RESOLUTION 23-196

A RESOLUTION TO APPROVE THE ACCEPTANCE OF A FEE IN LIEU FROM HAVERHILL PROPERTIES (FAST PACE HEALTH) FOR THE CONSTRUCTION OF BIKE LANES ON OLD PORT ROYAL ROAD

RE: STP 1363-2023 (TN Fast Pace Health)

**PROPOSED SITE FOR:
 FAST PACED HEALTH
 SPRING HILL, TENNESSEE**

**CALIBER COLLISION SANDIA CT
LANDSCAPE PLAN**

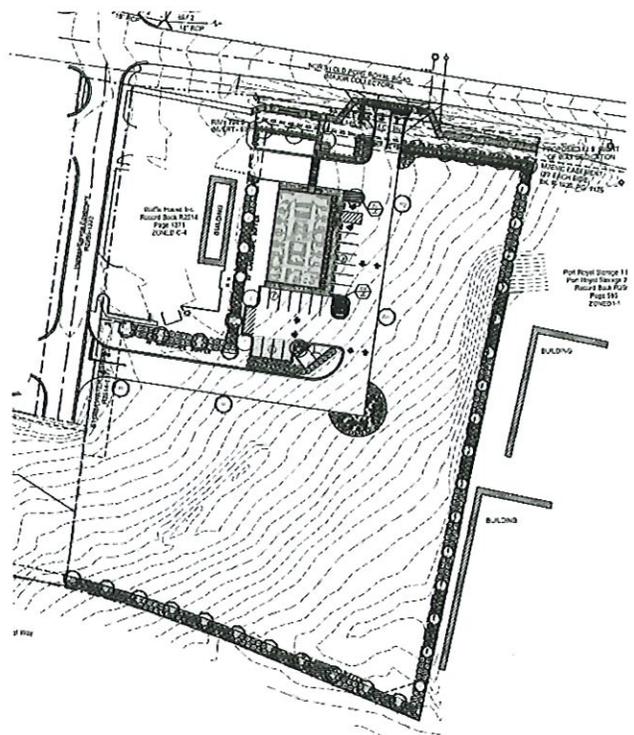
9. *If future subdivisions are to occur from the existing parent tract, future cross access easement and utilities easements will be required.*
10. *The landscape plan shown below shall be added to the civil plan/construction set and be labeled fast pace health vs. Caliber collision*
